### **REMARKS**

New claims 20 to 38 have been added each recite a vehicular screen antenna. Applicants respectfully submit the claim features in the above new claims are not taught by *Miyahara et al.*

**AMENDMENTS TO THE DRAWINGS:**

FIGURE 1 (Prior Art)

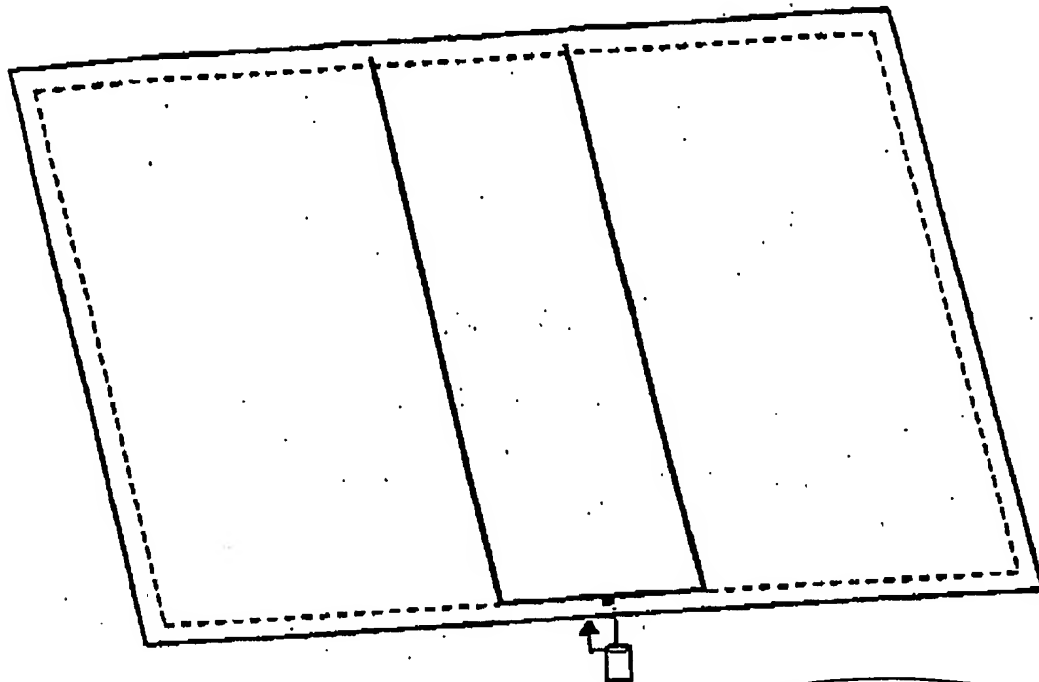
The Office Action, on page 3, suggests that Figures 1 and 2 be designated by a legend such as "Prior Art." In response, applicants amended Figures 1 and 2 as shown in the attached annotated and replacement sheets of the amended drawings.

The attached replacement sheet of drawings includes changes made to Figs. 1 and 2. This sheet, which includes Fig. 1 and 2, replaces the original sheet including the same figures. In Figs. 1 and 2, the legend "Prior Art" has been added as suggested in the Office Action.

Legend Added

FIGURE 2

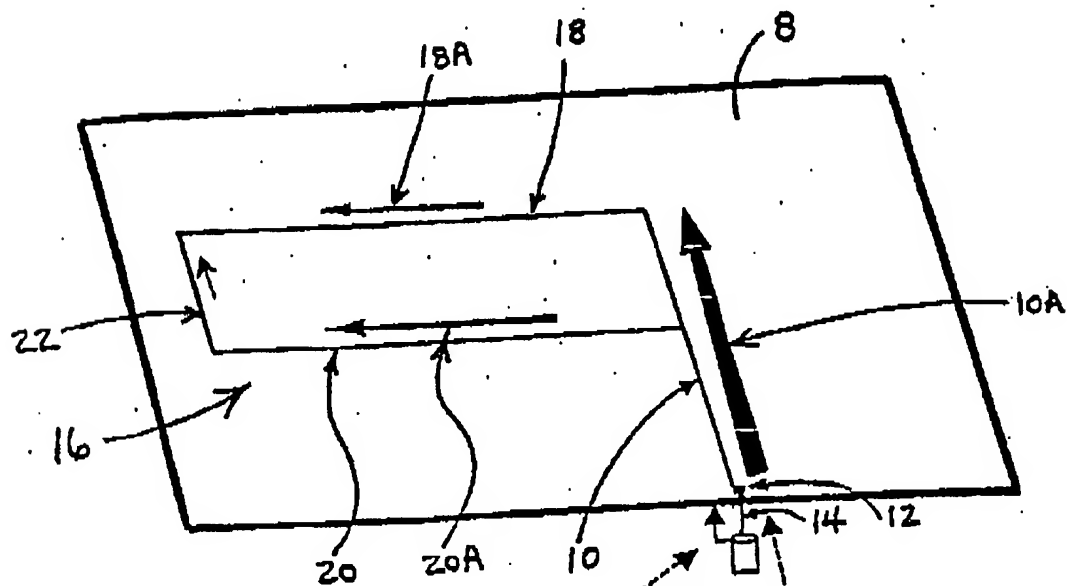
Legend Added \* (Prior Art)
